Report to the Future Melbourne Committee

Planning Permit Application: TP-2021-648 386-392 Lonsdale Street, Melbourne Presenter: Marjorie Kennedy, Head of Statutory Planning

DELEGATE REPORT PLANNING PERMIT APPLICATION

Figure 14 - Extracts from the Discussion Drawings dated 19 May 2022 showing the revised treatment to the gaming lounge and DOSA

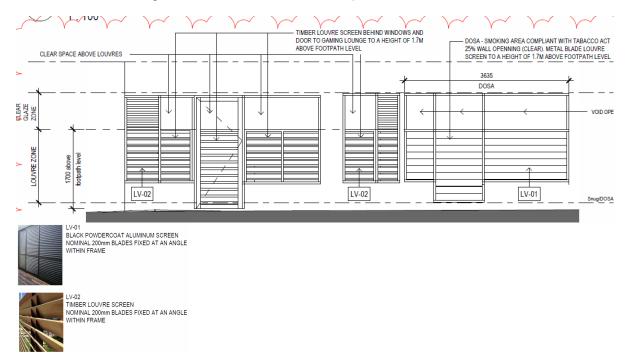
- Create a more positive relationship with the street by replacing the gaming machines adjacent to the windows with a more active program, or using a different type of screening material that adds visual interest, such as textured glass or channel glass.
- Relocate DOSA away from pedestrian activities.
- Remove the takeaway window and seating outside to ensure pedestrian safety.
- Ensure the awning height of above 3.5 m.

These concerns were forwarded to the permit applicant who submitted several discussion drawings to address the interface between the gaming lounge and adjacent laneway. The final version, dated 19 May 2022 shows the replacement of the dark window film with a combination of timber and metal blade louvers. This is considered to be a higher quality and more robust response to the streetscape, which achieves an acceptable balance between interactivity, daylight access and minimising views of the EGMs. A condition on any permit issued should therefore require the design changes shown in the aforementioned drawings to be included in the endorsed plans.

Figure 15 - Proposed partial demolition on the rooftop. From Drawing TP05

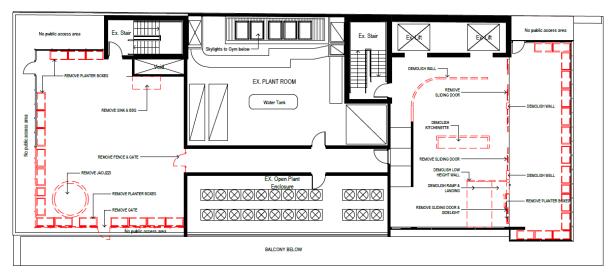
• Demolition of planter beds, some internal and external walls.

- Construction of planter beds on the outside of the retained glass balustrades.
- Construction of an outdoor bar and washroom facilities on the northern side of the rooftop services.
- Construction of a new roof over the new bar and washroom facilities, and retractable roofs over a portion of the northern roof terrace.
- Installation of new doors and glazing to the southern roof terrace.

Figure 16 - Proposed Roof Plan. From Drawing TP10

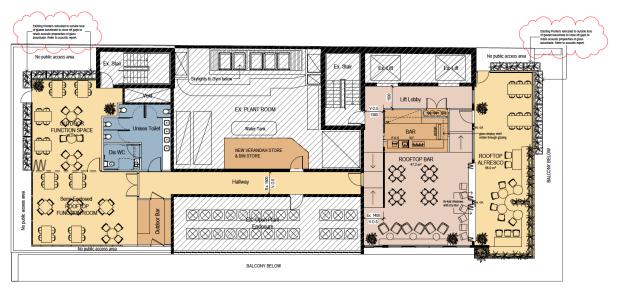
Our inspection of the glass balustrades indicate that they would provide mitigation similar to an acoustic fence, given that there are no gaps between the glass panes. While a small gap exists to the foot of the balustrade, there are planter boxes (that are to be retained) that effectively seals the gap.

This is inconsistent with the proposed rooftop plans which show the planter boxes removed and placed on the *outside* of the retained balustrades. As the report relies on their retention, this needs to be reflected in an updated report.

The proposal does, however, propose to locate planter boxes between the retained glass balustrades and the northern boundary. These planter boxes are greater than 300 mm in height and would be prohibited in accordance with Table 3 to DDO10. A condition on any permit issued must therefore require their deletion.

Owing to the fact that the submitted acoustic report is based on the proposed planter boxes, it would also need to be updated to reflect the amendment.
